ORDER FOR SUPPLIES OR SERVICES

Location: Pearl Harbor FISC, HI
Project: Clean, Inspect, and Repair Storage Tanks 2 and 20

**Statement of Work
Clean, Inspect, and Repair Storage Tanks**

AMENDMENT OF SOLICITATION/MODIFICATION OF CONTRACT			1 CONTRACT ID CODE J	PAGE OF PAGES 1 4
2 AMENDMENT/MODIFICATION NO 01	3 EFFECTIVE DATE 05-Nov-2008	4 REQUISITION/PURCHASE REQ NO ACGR528772		5 PROJECT NO (If applicable)
6 ISSUED BY NAVAL FACILITIES ENG NEER NG COMMAND SPECIALTY CENTER ACQUISITIONS NAVFAC CODE RAQND/NAVAL BASE VENTURA COUNTY 1205 M LL RD BLDG 850 PORT HUENEME CA 93043-4347	CODE N62583	7 ADMINISTERED BY (If other than item 6) See Item 6

Image# 3: Showing Tank #20 Tower frame and boom recommendations

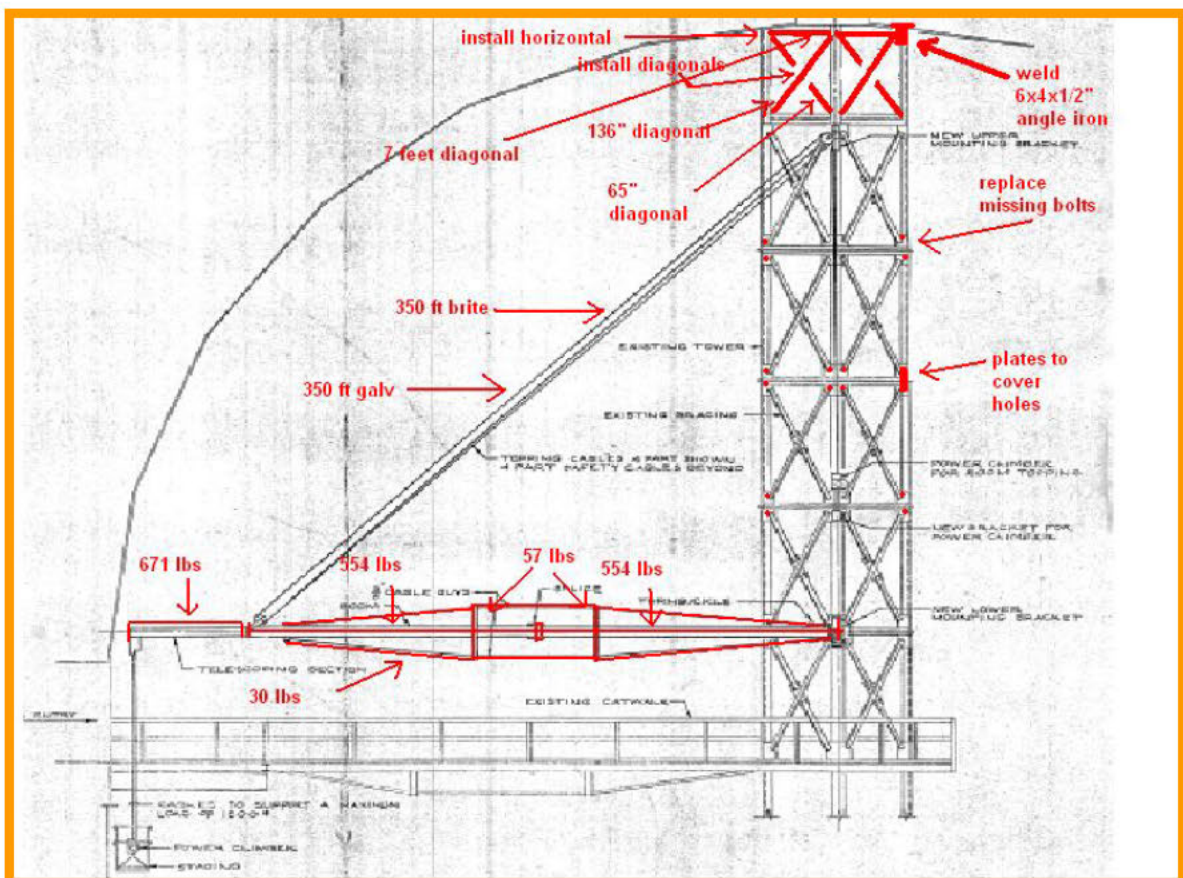
Image# 2: Showing Tank #20 Tower leg not welded to the tank.

All above proposed changes were accomplished safely.
